Product / Process Change Notification (PCN)					
PCN #:	PCN_WCAP-ASLL_20220421	Change Category:			
Affected Series: PCN Date: Effective Date:	WCAP-ASLL  January 21, 2022  April 21, 2022	<ul> <li>□ Equipment / Location</li> <li>☑ General Data</li> <li>□ Material</li> <li>□ Process</li> <li>□ Product Design</li> <li>□ Shipping / Packaging</li> <li>□ Supplier</li> </ul>			
		□ Software			
Contact:	Product Management	Data Sheet Change:			
Phone:	+49 (0) 7942 - 945 5001	⊠ Yes □ No			
Fax:	+49 (0) 7942 - 945 5179	Attachment:			
E-Mail:	pcn.eisos@we-online.com	☐ Yes			
DESCRIPTION AND PURPOSE OF CHANGE:  Because of a database mismatch, Würth Elektronik will update all datasheets for the Matchcode WCAP-ASLL.  The component Marking will be changed to the current state of art.

## **Datasheet Update**

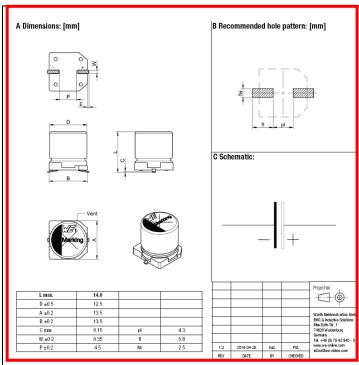
Würth Elektronik will update the datasheet layout in general for all WCAP-ASLL datasheets. Furthermore with this layout update Würth Elektronik will correct the electrical and mechanical characteristics. All corrections in terms of electrical characteristics are shown below. They will also be clearly visible in the new datasheets which Würth Elektronik will provide on the website shortly.

(This is a datasheet correction only. There will be no change in form, fit, function, quality or reliability of the product.)

## Example for drawings with indirect dimensioning

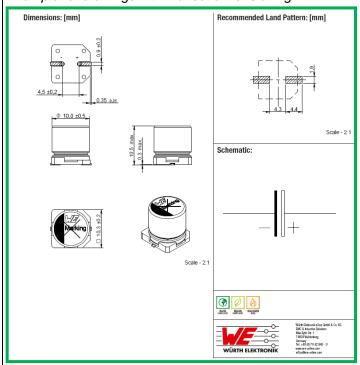
• All corrections in terms of mechanical characteristics are shown. In order to visualize the corrections of the dimensions example of the old and the new drawings is shown below. Würth Elektronik will update the dimensioning from an indirect dimensioning to a direct dimensioning:

In the course of the update from indirect to direct dimensioning the values for the dimensions and tolerances will be updated. The upcoming corrections can be seen more detailed in the pictures above.
